# ADDENDUM No. 1

## RFP No. 22-25

### Geddes & Huron Parkway/Tuebingen Resurfacing Project

**Bids Due: May 5, 2022 at 10:00 A.M. (Local Time)**

FIRE HYDRANT WITH TAPPING SLEEVE AND VALVE

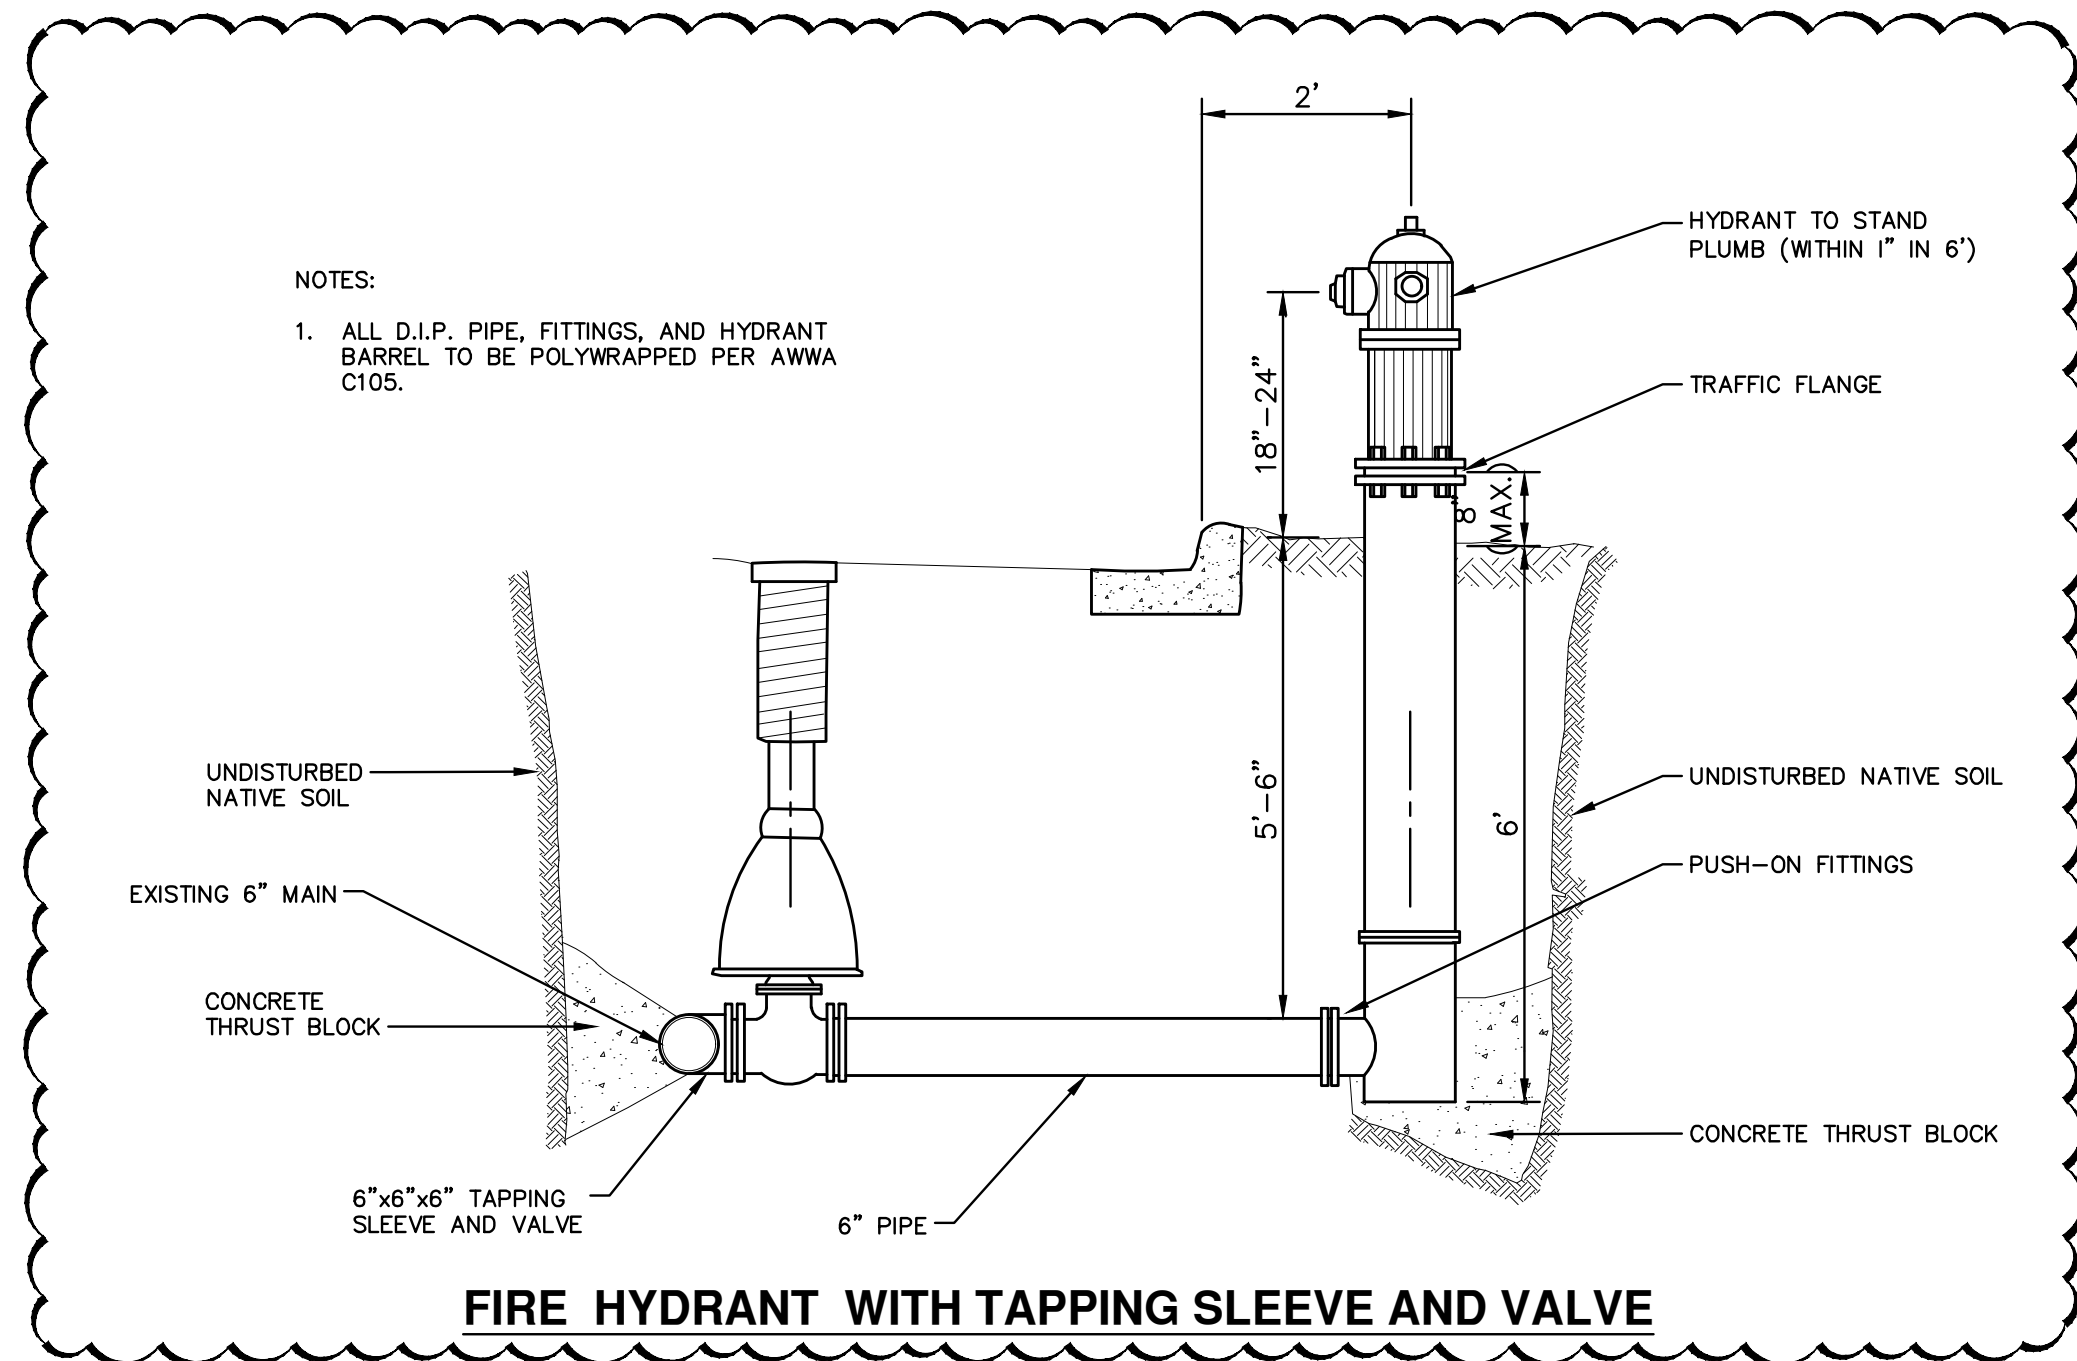
Sheet 8	Revised Hydrant Assembly Detail to include a tapping sleeve and valve.
Sheet 10	Added detail of Decorative Aluminum Fence to replace existing in front of 2026 Geddes Ave.
Sheets 18, 27	Added notes plus removal and construction keys to include removal and replacement of an electrical and communications handhole.
Sheets 20, 29	Added notes plus removal and construction keys regarding removal and reinstallation of existing decorative fencing in front of 2024 Geddes, and removal and replacement of decorative fencing in front of 2026 Geddes Ave.
